The layout of the **Preliminary Plat of Cedar Lake Estates No. 14**, P.P. # 70-14-03-300-058, part of P.P. # 70-14-03-300-052 and part of P.P. # 70-14-03-300-055, located at 8955 Cedar Lake Dr. and 2126 Fillmore, zoned LDR (Low Density Residential) and RR (Rural Residential), Georgetown Township, Ottawa County, Michigan.

The request is for preliminary plat approval of Cedar Lake No. 14 with 24 lots in the LDR district.

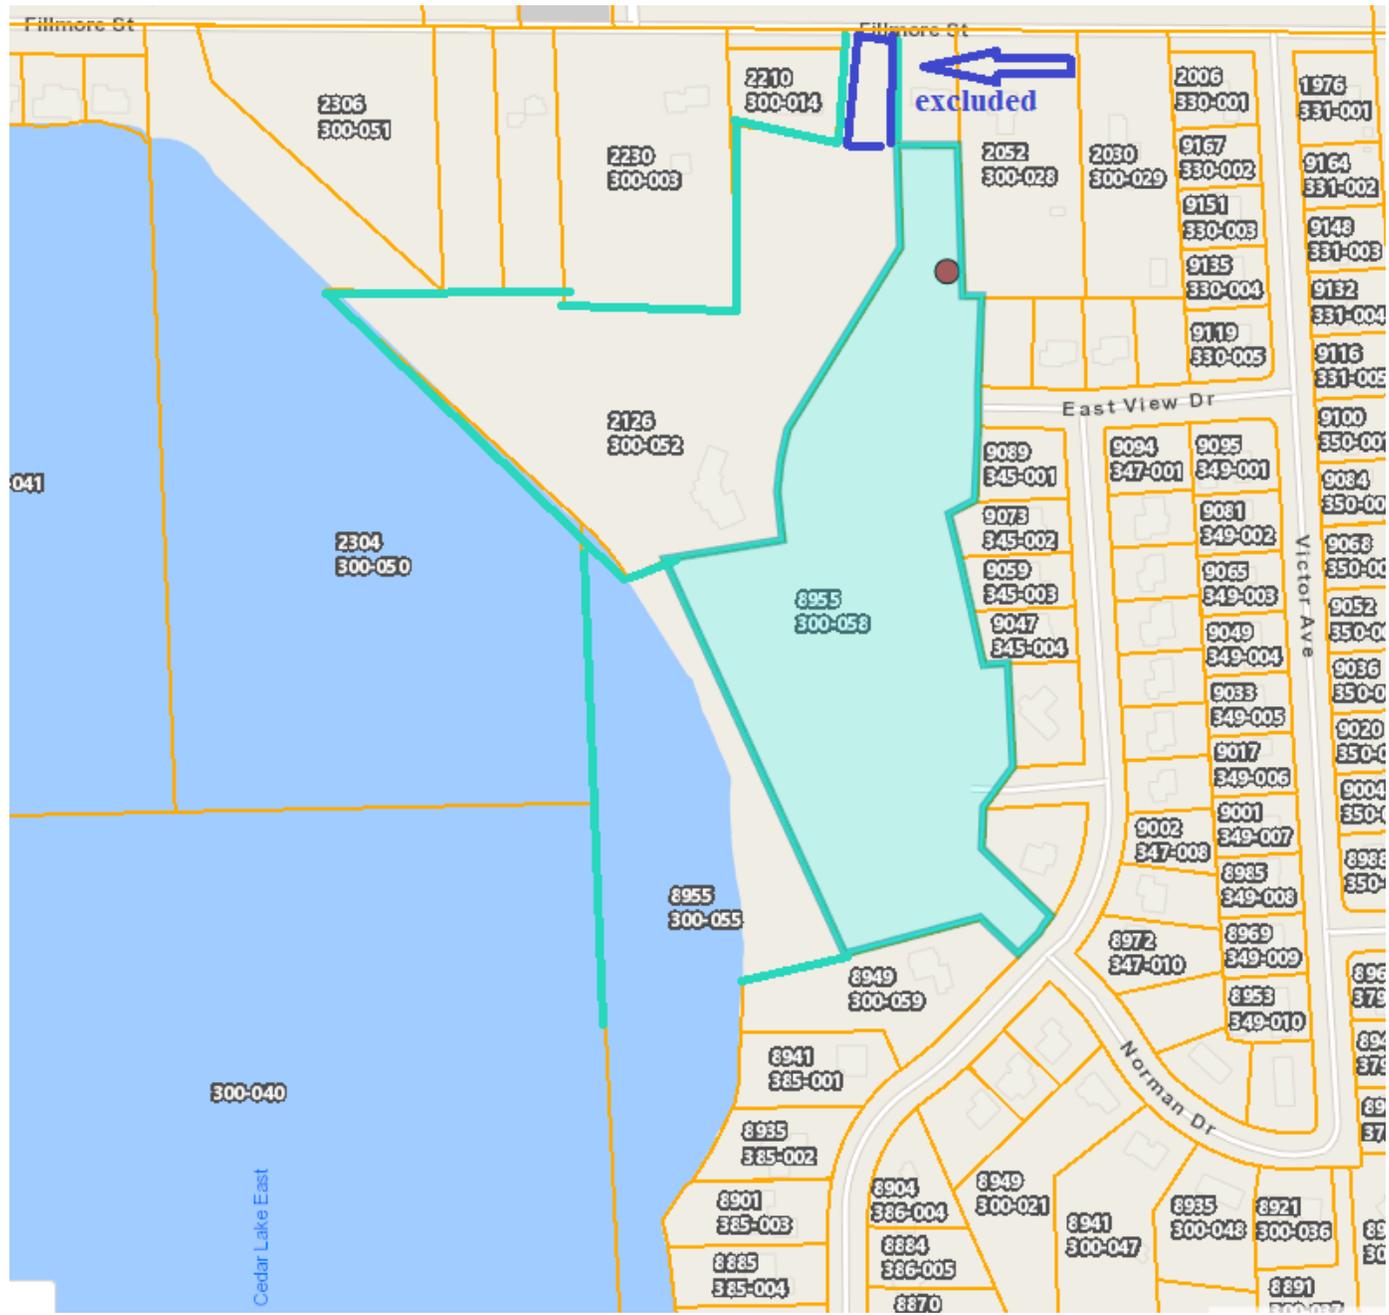
- d. The zoning of adjacent property is all LDR except to the west is RR. **Part of P.P. # 70-14-03-052 (consisting of the western portion lots 260, 261 and 262) is zoned RR. The portion of land within the plat that is zoned RR does not contain the width which is determined adjacent to the street, nor the houses. Setbacks for the houses are not affected. Square footages of the lots are: lot 260 = 87,100 SF; lot 261 = 59,515; and lot 262 = 79,560. All exceed the minimum of 15,000 SF for lots in the RR district services by public water and sanitary sewer. Although this does not affect the plat at this time, the developer may want to rezone that portion of the lots to LDR to be consistent with the rest of the plat and to avoid any problems in the future that could arise.**

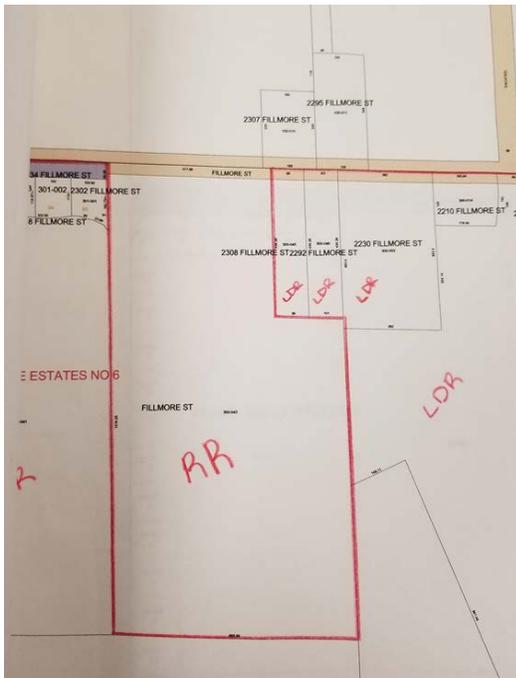
- a. Building envelopes appear to meet ordinance requirements, but will be reviewed for exactness at the time a building permit application is submitted. **The driveway for lot 262 encroaches upon lot 261. How will that situation be remedied?**

The plan shows an exception along Fillmore which is excluded from the plat. The exclusion has a width of 91 feet, which meets the ordinance requirement for a lot in the LDR district that is serviced by public water and sanitary sewer; however, the lot does NOT meet the minimum width of 95 feet which is required for a lot not serviced by public water and sanitary sewer. Therefore, **the lot created by the exception shall be connected to public water and sanitary sewer. Provide evidence, such as a letter signed by the developer, stating that the lot created by the exception shall be connected to public water and sanitary sewer prior to any development taking place on it.**

- f) The lot created by the exception shall be connected to public water and sanitary sewer. Provide evidence (i.e. signed letter stating that the lot created by the exception shall be connected to public water and sanitary sewer prior to any development taking place on it).
